TRANS/WP.29/GRRF/2002/17/Rev.2
6 June 2003

PROPOSAL FOR DRAFT AMENDMENTS TO REGULATION No. 64
(Temporary use spare wheels/tyres)

Revision 2

Transmitted by the Expert from the United Kingdom

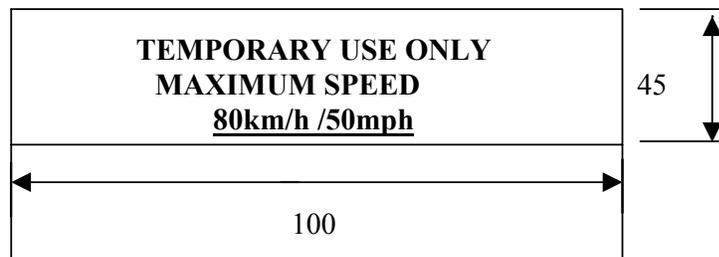
Paragraph 5.1.4.1., amend to read (the diagram is not amended):

"5.1.4.1. An 80 km/h maximum speed warning symbol arranged in accordance with the diagram below, shall be permanently displayed on the outer face of the wheel in a prominent position.

In the case of vehicles intended to be sold in countries using imperial units of measurement, an additional warning symbol, identical to that described above, with the exception that the figure "80" shall be replaced by "50" and the wording "km/h" by "mph", shall be permanently displayed on the outer face of the wheel in a prominent position.

Upper case letters shall be at least 5 mm high and the numbers "80" and "50" shall be at least 20 mm high with the elements that make up each character of the number at least 3 mm line thickness. Lower case text shall be at least have a line height of 5 mm. All text shall be enclosed in a border and be on a background of contrasting colour.

The requirements of this paragraph shall not apply to a temporary use spare wheel and tyre unit that includes or comprises either a run-flat system tyre or a uni-directional tyre."
